Access Compliance Report Public Rights-of-Way (Curb Ramps)

Main Street: WASHINGTON_AVE **Cross Street:** WILSON_ST **Location:** NW

ADA ID: RPRK210930183104 **Ramp Type:** Type 1 - Perpendicular Diagonal Initial Pass/Fail: Fail **Overall Compliance:** No **Severity Score:** 20

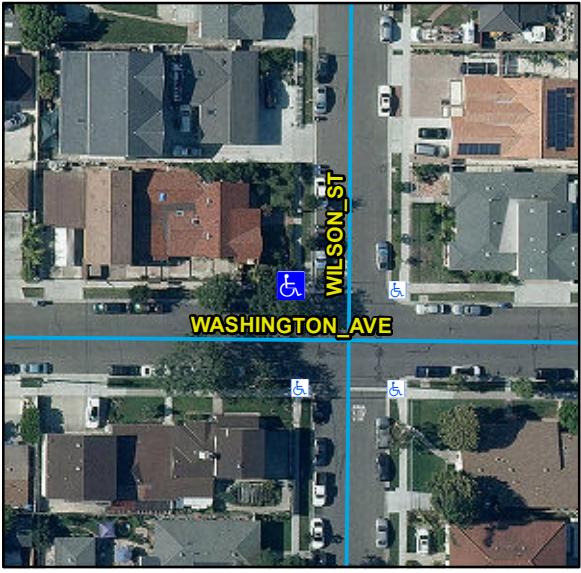
OC Std/PROW:
 R204.3, R304.5.1, R304.2.2, R304.5.3, STD 1115

Compliance	Description	Data	Compliance	Description	Data
N/A	Ramp Length (in)	105	N/A	Flare Type LT	
No	Ramp Width (in)	36			N/A
No	Ramp Run Slope (%)	10.9	N/A	Flare Slope LT (%)	N/A
No	Ramp Cross Slope (%)	2.9	N/A	Flare Traversable LT	N/A
N/A	Landing Present	N/A	N/A	Flare Type RT	
N/A	Landing Length (in)	N/A			N/A
N/A	Landing Width (in)	N/A	N/A	Flare Slope RT (%)	N/A
N/A	Landing Run Slope (%)	N/A	N/A	Flare Traversable RT	N/A
N/A	Landing Cross Slope (%)	N/A	N/A	DWS Provided	N/A
N/A	Landing Movement Obstructed?	N/A	N/A	DWS Contrast	N/A
	Landing Movement Type	N/A	N/A	DWS Length (in)	N/A
N/A	Landing Shared	N/A	N/A	DWS Full Width	N/A
N/A	Clear Space	Yes	N/A	DWS Offset Left (in)	N/A
N/A	Clear Space To Crosswalk (in)	N/A	N/A	DWS Offset Right (in)	N/A
N/A	Marked Crosswalk 1	No	N/A	Marked Crosswalk 2	No
	Crossing 1 Direction	S		Crossing 2 Direction	E
	Marked Crosswalk 1 Width (in)	N/A		Marked Crosswalk 2 Width (in)	N/A

Possible Solutions:
Remove & Replace Curb Ramp With Two New Directional Ramps or Equivalent.
